DRIVE LANE A - SITE PLAN FOR INFRASTRUCTURE

CITADEL ON COLFAX SUBDIVISION FILING NO. 1 & 2 CITY OF AURORA, COUNTY OF ARAPAHOE, STATE OF COLORADO

CITADEL ON COLFAX SUBDIVISION FILING NO. 1
LOT 2, BLOCK 8 - DRIVE LANE A (PRIVATE)
INFRASTRUCTURE SITE PLAN

LANDSCAPE PLAN

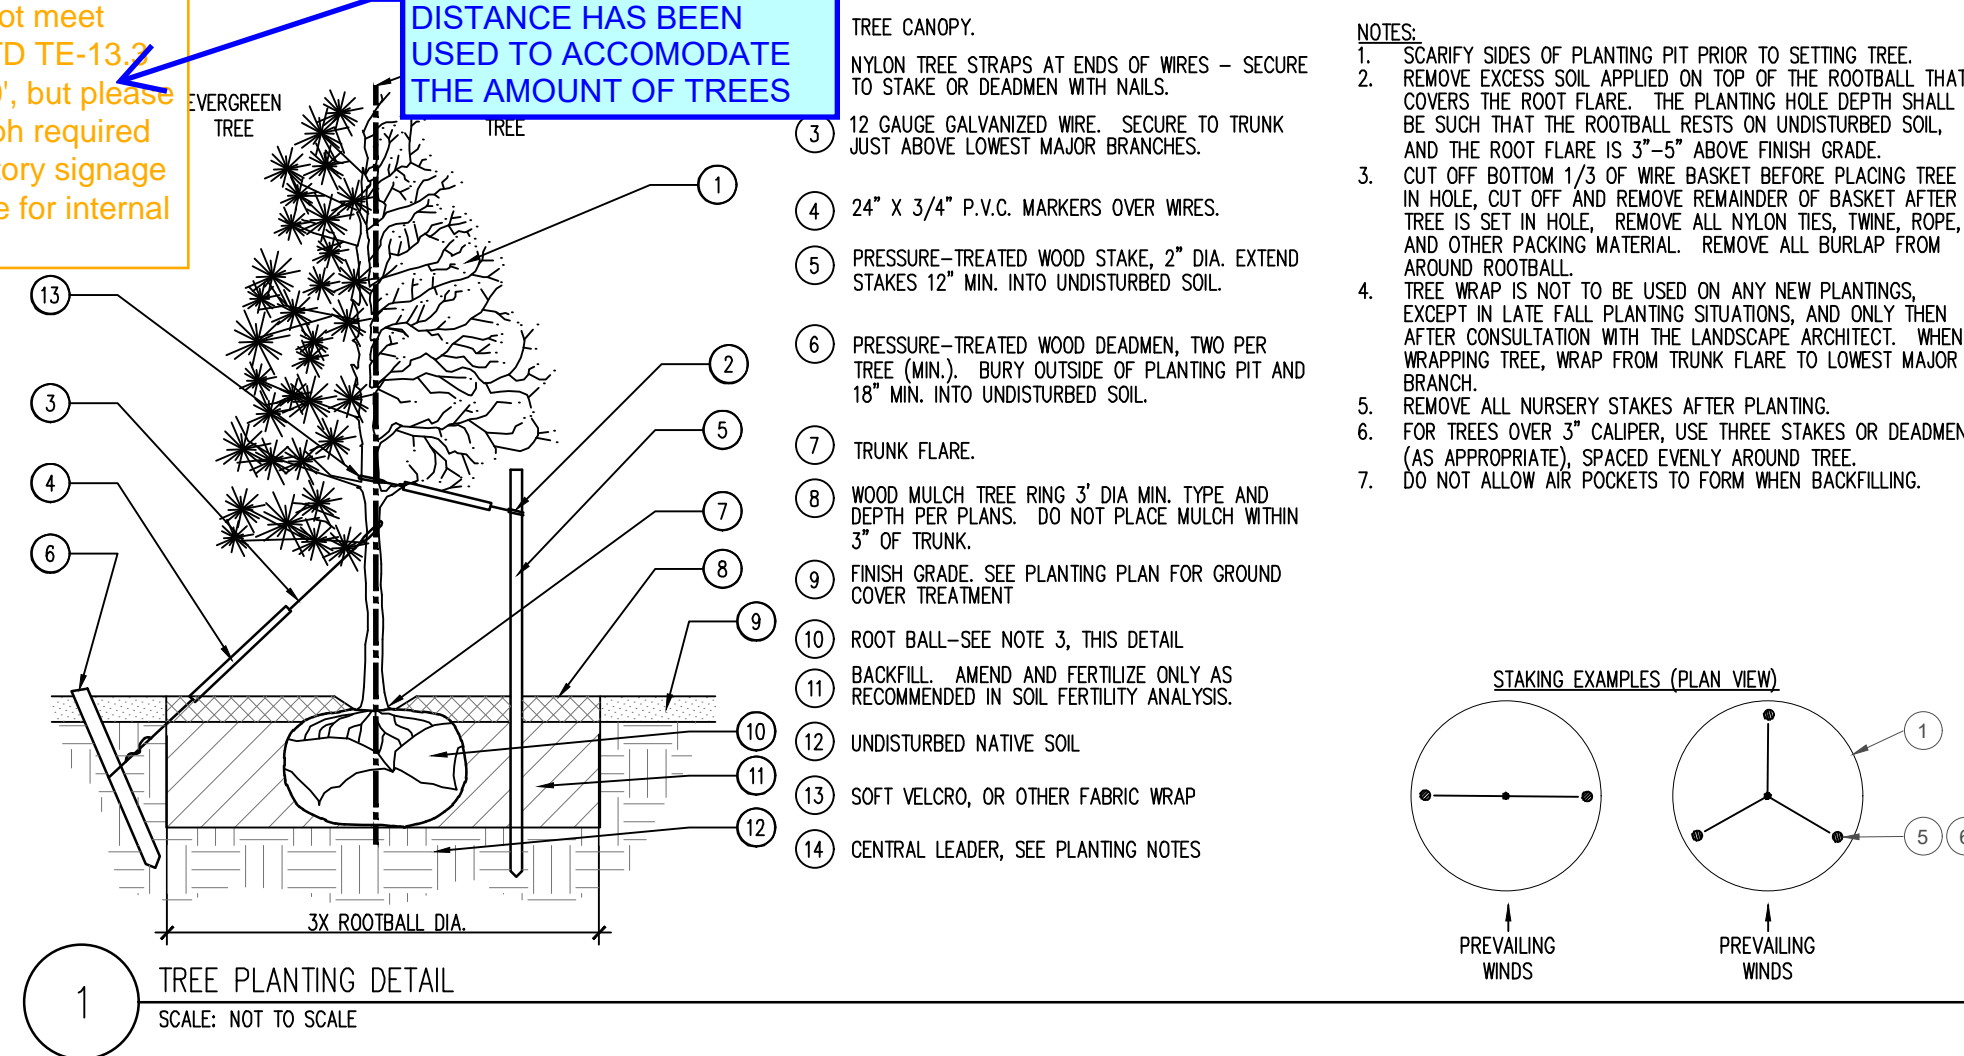
These two columns can be combined into one to avoid confusion.

Repeated comment - This tree placement does not meet criteria in COA STD TE-13.7 (relocate). Min 50', but please also use the 20mph required distance. Regulatory signage needs to be visible for internal drives.

GALLOWAY RESPONSE: COMPLETED

GALLOWAY RESPONSE: COMPLETED. THE MINIMUM 50' CLEAR DISTANCE HAS BEEN USED TO ACCOMMODATE THE AMOUNT OF TREES
